DATE: November 2, 2016

**TO:** Design Review Commission  
**FROM:** Sean K. Gallegos, Assistant Planner  
**SUBJECT:** 16-SC-50 – 318 South Clark Avenue

Design review modification application to revise an approved new two-story house. The modification would increase the project's second story roof pitch from 4:12 to 5:12.

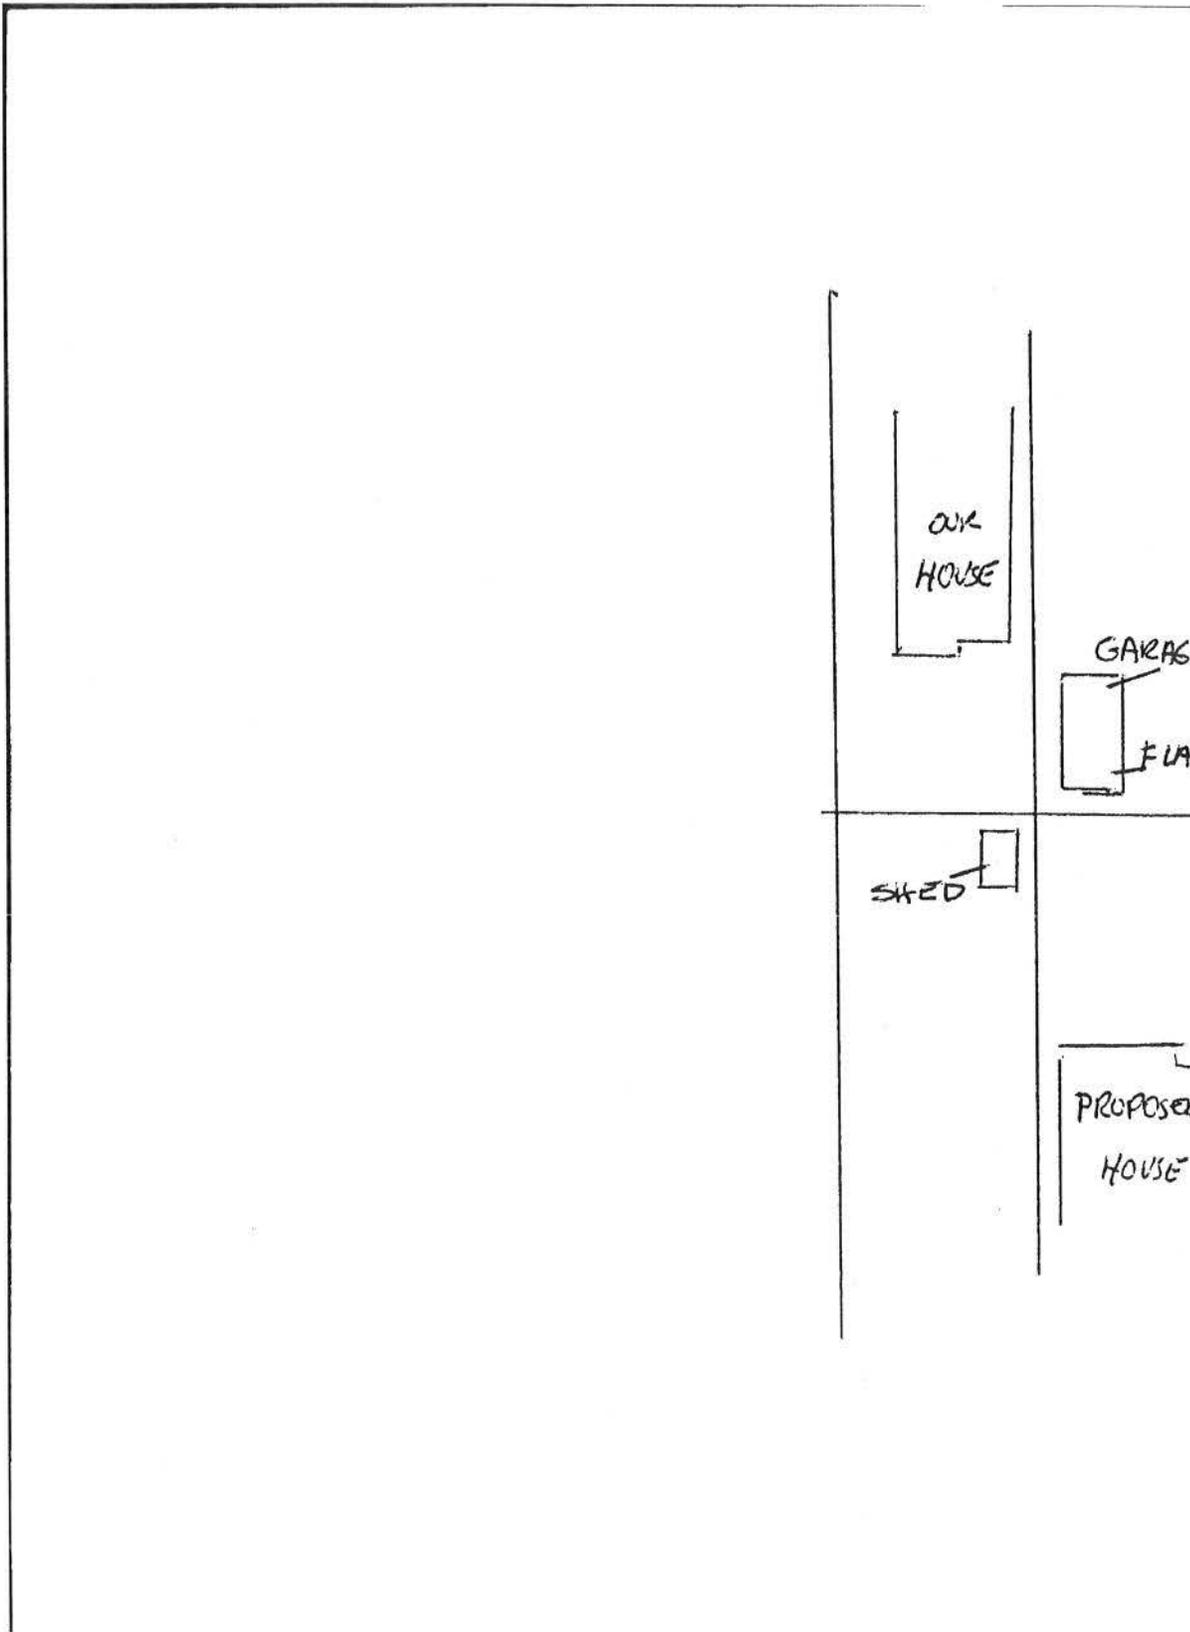
Our issue with the plans are the second story windows (5 in all). **These 5 windows will all have a DIRECT line of sight into our main living spaces – kitchen and family room**. (see attached photo – taken from our kitchen table area)

Providing screening is sometimes seen as a solution to privacy concerns but in this case planting is not enough since two of our neighbors have existing low lying structures that make it impossible for them to plant screens of any kind. (see second attachment). In my opinion effective screening needs planting from multiple sides of a fence otherwise it never achieves the actual density needed for privacy.

- Eliminate the rear facing bathroom windows and instead install a skylight for light and ventilation. Move the egress window to the side.
- Eliminate the master bedroom rear windows and move the egress window to the side. A skylight again is an option.
- Increase the screening at the rear of the yard by replacing the far round patio with more screening bushes. In addition, reduce the size of the vegetable garden so more screening bushes can be planted along that fence.
